Customer :	CU-DAR001 Dart Helicopters Services	Drawing Name :	HELI UTILITY BASKET LH/RH 350/355
Job Number :	33000	Part Number :	D350607043
Estimate Number :	10208	Drawing Number :	D350-607 REV F P7-9
P.O. Number :	NIA	Project Number :	N/A
This Issue :	6/19/2007 S.O. No. : NIA	Drawing Revision :	F
Prsht Rev. :	NC	Material :	NIA
First Issue :	NIA	Due Date :	7/12/2007
Previous Run :	32999	Type :	LARGE FAB ASSY
Written By :			
Checked & Approved By :	07.06.20		
Comment :	Est Rev:E as Per DSI9318 06-01-24 JLM

DESIGN <i>CP</i>	DRAWN BY <i>CP</i>	DART AEROSPACE LTD HAWKESBURY, ONTARIO, CANADA	
CHECKED <i>[Signature]</i>	APPROVED <i>[Signature]</i>	DRAWING NO. DSI 9318	REV. A SHEET 1 OF 1
DATE 06.01.06		TITLE WASHER ADDITION	SCALE NTS
A	06.01.06	NEW ISSUE

## DART SERVICE INSTRUCTION

TO AMEND INSTALLATION INSTRUCTIONS D350-607 REV. F

**Figure 5- Basket Replacement Parts**  
(D350-607-043 Heli-Utility-Basket™)

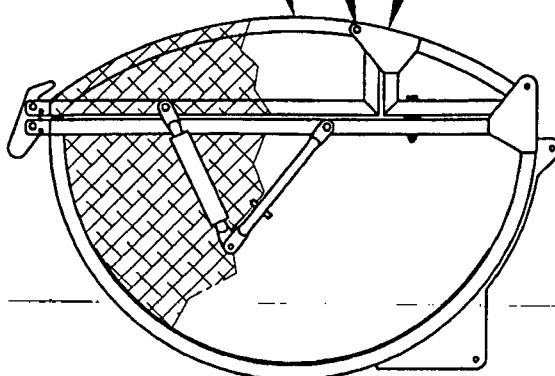
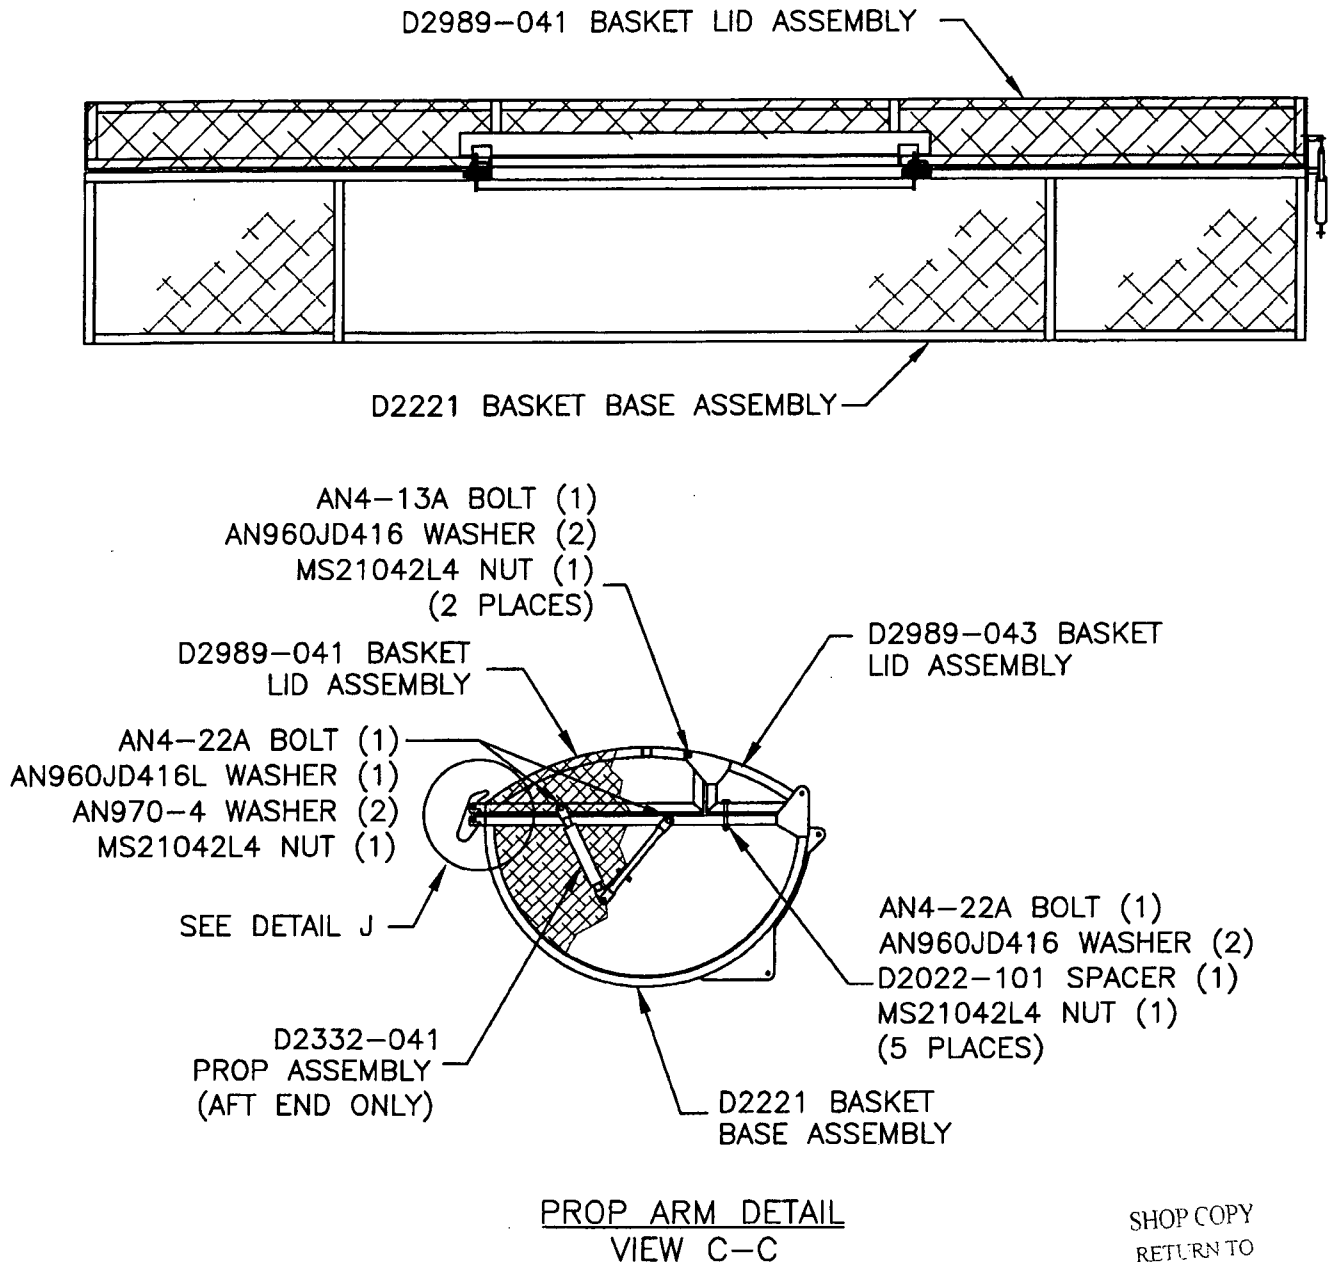
To reduce the possibility of damaging the finish, a **NAS1515H4** washer (2 places) has been added between the hinge plate and basket frame on the **D350-607-043/-047 Heli-Utility-Basket**.

The corrected bolt stackup from Figure 5 of installation instructions D350-607 Rev. F is given below:

AN4-13A BOLT (1)  
AN960JD416 WASHER (1)  
HINGE PLATE (REF)  
**NAS1515H4 WASHER (1)**  
BASKET FRAME (REF)  
AN960JD416 WASHER (1)  
MS21042L4 NUT (1)  
(2 PLACES)
